City of Murrieta Municipal Separate Storm Sewer System (MS4) Inspection Report

City of Murrieta - Municipal Separate Storm Sewer System (MS4) (Order No. R9-2004-001) Exhibit Log

Exhibit 6 – Documentation of exceedances of the TDS numeric criterion (TDS > 0.9375 g/L) as reported at the California Oaks Channel and Catt Road Stations on September 12, 2006 and May 24, 2007

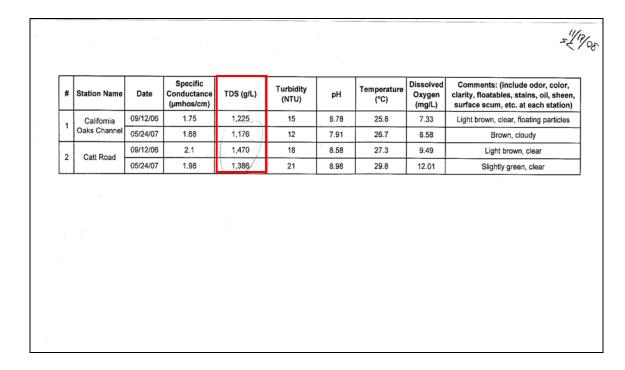
monitoring results that will trigger follow-up investigations to identify the source causing the exceedance of the criteria." Pursuant to this requirement, the Consolidated Monitoring protocol Section 3.4.9 establishes the numeric criterion for Total Dissolved Solids (TDS) as "> 25% higher than WQO" (see attached Exhibit 5). The Water Quality Control Plan for the San Diego Basin, dated September 8, 1994 (hereafter, Basin Plan) specifies a TDS Water Quality Objective (WQO) for the Murrieta Hydrologic Area (HA) at 0.75 g/L. The permittee's resulting numeric criterion for TDS is 0.9375 g/L. Exceedances of this TDS numeric criterion were reported at the California Oaks Channel Station on September 12, 2006 (TDS = 1,225g/L) and May 24, 2007 (TDS = 1,176 g/L) (see attached Exhibit 6). Exceedances of the TDS numeric criterion were reported at the Catt Road Station on September 12, 2006 (TDS = 1,470 g/L) and May 24, 2007 (TDS = 1,386 g/L) (see attached Exhibit 6). Exhibit 7 provides a summary of the reported field screening exceedances and numeric criteria calculations. As provided by Ms. Naceem, she was unaware that the reported values were in exceedance of the numeric criterion and therefore had not conducted follow-up investigations to identify the source causing the exceedances. Monitoring and Reporting Program No. R9-2004-001, Section II.B.3, requires that "in the event of an exceedance of the criteria, Permittees shall implement the followup investigation procedures developed pursuant to section J.4 of Order No. R9-2004-001."

In the event of an exceedance of the numeric criteria, Monitoring and Reporting Program No. R9-2004-001 Section II.B.3 requires implementation of the follow-up investigation procedures developed pursuant to Requirement J.4. of the Order.
